# Access Compliance Report

## Public Rights-of-Way

### (Curb Ramps)

Intersection ID: 42670	Main Street: WALLACE_CABIN_DR	Cross Street: WALLACE_CREEK_LN	Location: SE
ADA ID: 97624A3EABE9	Ramp Type: PerpDiag	Initial Pass/Fail: Fail	Overall Compliance: No
		Severity Score: 8.75

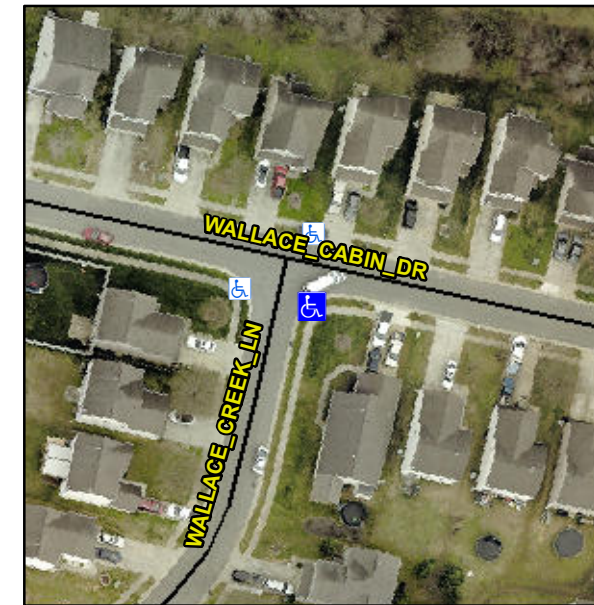
**R304.5.1**

Compliance	Description	Data	Compliance	Description	Data
N/A	Ramp Length (in)	50.5	Yes	Ramp Slope (%)	5.0
No	Ramp Width (in)	37.5	Yes	Ramp XSlope (%)	1.9
N/A	Flare Type LT	N/A	N/A	Flare Type RT	N/A
N/A	Flare Slope LT (%)	N/A	N/A	Flare Slope RT (%)	N/A
N/A	Flare Traversable LT?	N/A	N/A	Flare Traversable RT?	N/A
N/A	Landing Length (in)	N/A	N/A	DWS Provided?	N/A
N/A	Landing Width (in)	N/A	N/A	DWS Contrast?	N/A
N/A	Landing Slope (%)	N/A	N/A	DWS Length (in)	N/A
N/A	Landing X Slope (%)	N/A	N/A	DWS Full Width?	N/A
N/A	Landing Curb? (Y/N)	N/A	N/A	DWS Offset (in)	N/A
N/A	Shared Landing?	N/A			
N/A	Gutter Ponding?	N/A	N/A	Gutter Slope (%)	N/A
N/A	Gutter Lip Ht (in)	N/A	N/A	Gutter X Slope (%)	N/A
N/A	Painted X Walk1?	No	N/A	Painted X Walk2?	No
	X Walk 1 Direction	To N		X Walk 2 Direction	To W
N/A	X Walk 1 Width (in)	N/A	N/A	X Walk 2 Width (in)	N/A
	X Walk 1 Slope (%)	2.4		X Walk 2 Slope (%)	0.8
	X Walk 1 X Slope (%)	0.0		X Walk 2 X Slope (%)	3.9

**Remove & Replace Curb Ramp With Two New Directional Ramps or Equivalent.**
